GNN Project No.: 217-854

Subject: MEMO: Review of Revised Expansion Plans
Proposed Mission Ridge Ski Resort Expansion Project
Chelan County, Washington

Ecosign Resort Planners Ltd., November 20, 2019. Plan set for Mission Ridge, 19 sheets.

Attachment: Site Features and Geologic Constraints (A-3)

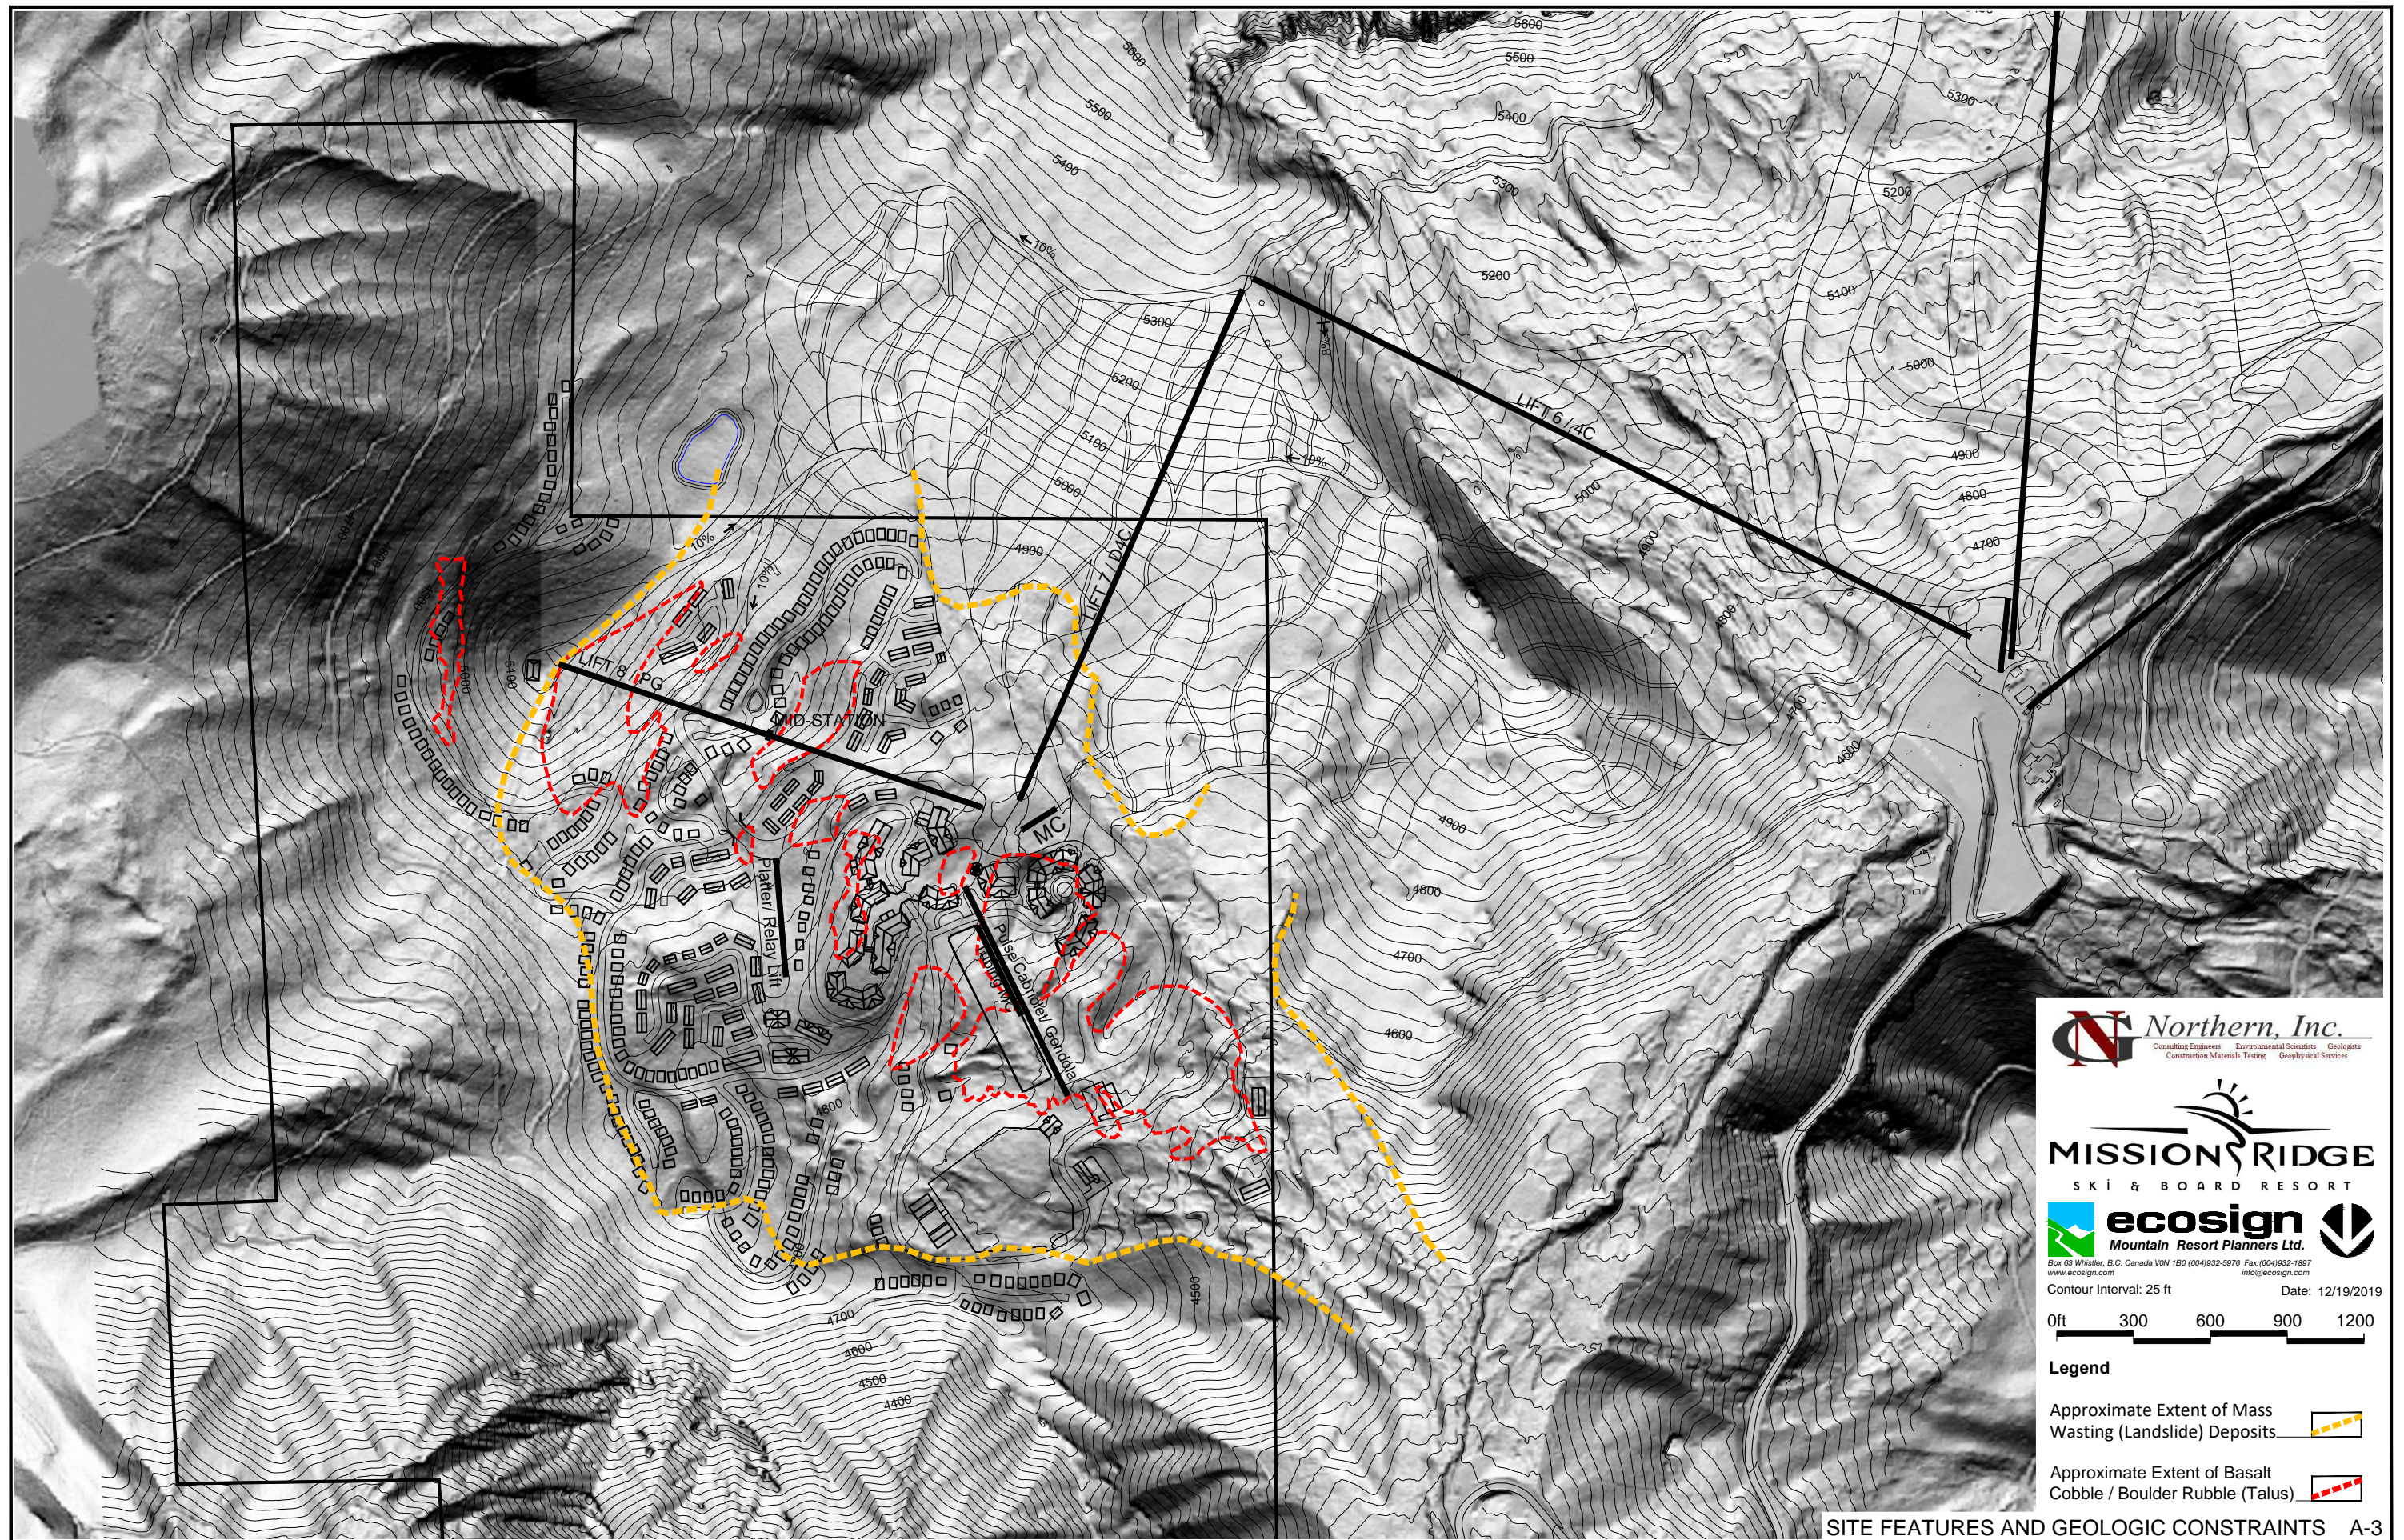
The attached *Site Features and Geologic Constraints* map shows revised reconnaissance-level boundaries of the noted mass wasting and talus deposits based on a site-specific digital elevation model (DEM) surface not available at the time of the referenced report. Therefore, the attached map supersedes Figure No. 2 of the referenced report.

Based on our review of the revised expansion plans, we have determined that the findings, conclusions, and recommendations of the referenced geologic hazards report remain valid.
